# UNITED STATES PATENT AND TRADEMARK OFFICE

APPLICATION NO.	FILING DATE	FIRST NAMED INVENTOR	ATTORNEY DOCKET NO.	CONFIRMATION NO.
10/786,307	02/26/2004	Ye-Yong Kim	IK-0072	3458
34610	7590	11/03/2005	EXAMINER	
FLESHNER & KIM, LLP P.O. BOX 221200 CHANTILLY, VA 20153			CHANDRAN, BIJU INDIRA	
			ART UNIT	PAPER NUMBER
			2835

<b>Office Action Summary</b>	Application No. 10/786,307	Applicant(s) KIM ET AL.	
	Examiner Biju Chandran	Art Unit 2835

**DETAILED ACTION*****Drawings***

FIG. 9

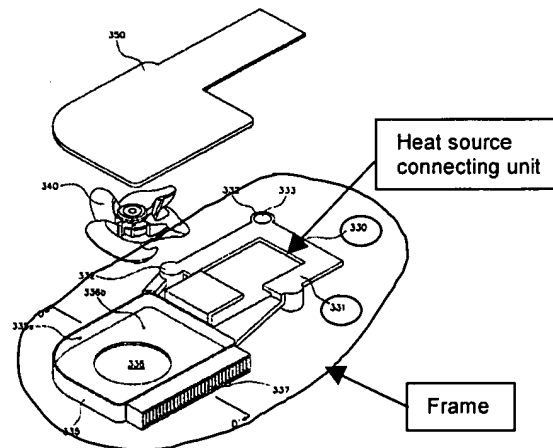
1. The drawings are objected to under 37 CFR 1.83(a). The drawings must show every feature of the invention specified in the claims. Therefore, the "dissipating unit" of claim 1, and the "transfer region" of claim 15 must be shown or the feature(s) canceled from the claim(s). No new matter should be entered.
2. The drawings are objected to because the "frame" and "heat-source connecting unit" claimed in claims 1-7, and 16-21 appear to point to the same feature in Figure 9. The examiner has assumed that the entire structure shown in the lower part of figure 9 to be the frame and the part of the frame on the right side to be the heat-source connecting unit.

Corrected drawing sheets in compliance with 37 CFR 1.121(d) are required in reply to the Office action to avoid abandonment of the application. Any amended replacement drawing sheet should include all of the figures appearing on the immediate prior version of the sheet, even if only one figure is being amended. The figure or figure number of an amended drawing should not be labeled as "amended." If a drawing figure is to be canceled, the appropriate figure must be removed from the replacement sheet, and where necessary, the remaining figures must be renumbered and appropriate changes made to the brief description of the several views of the drawings for consistency. Additional replacement sheets may be necessary to show the renumbering of the remaining figures. Each drawing sheet submitted after the filing date of an application must be labeled in the top margin as either "Replacement Sheet" or "New Sheet" pursuant to 37 CFR 1.121(d). If the changes are not accepted by the examiner, the applicant will be notified and informed of any required corrective action in the next Office action. The objection to the drawings will not be held in abeyance.

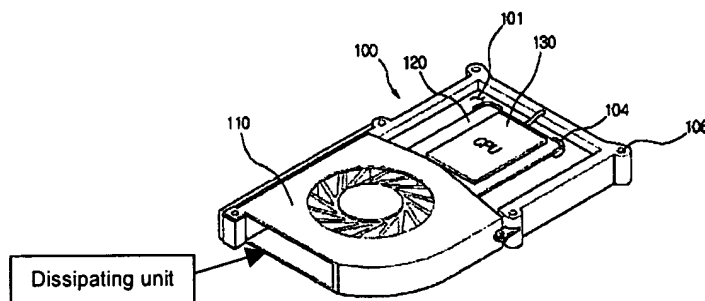
3. The disclosure is objected to because of the following informalities: The applicant seems to refer to the apparatus as "dissipating plate" ("100" in figure 2). While the applicant is entitled to be his own lexicographer, conventional art-accepted terminology is recommended. Recommend

naming the apparatus "cooling device" or some such term. Appropriate correction is required.

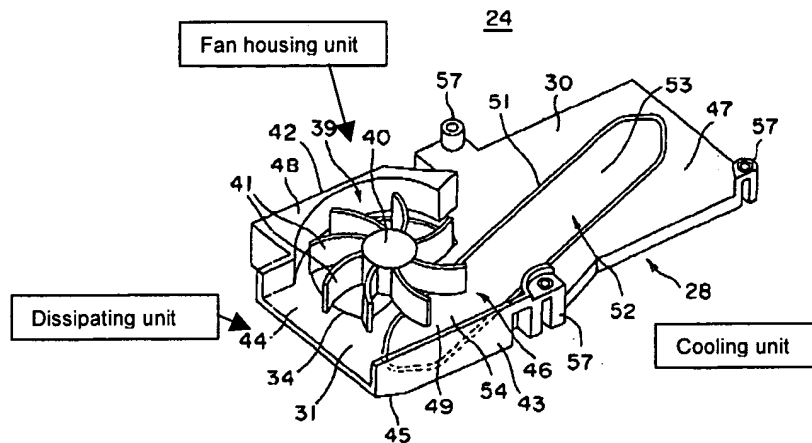
4. Claims 1-7 & 16-21 are rejected under 35 U.S.C. 112, second paragraph, as being indefinite for failing to particularly point out and distinctly claim the subject matter which applicant regards as the invention. With respect to these claims, it is unclear from the specification what the applicant is referring to as the "dissipating unit". The examiner has interpreted the dissipating unit as illustrated in the figure below.
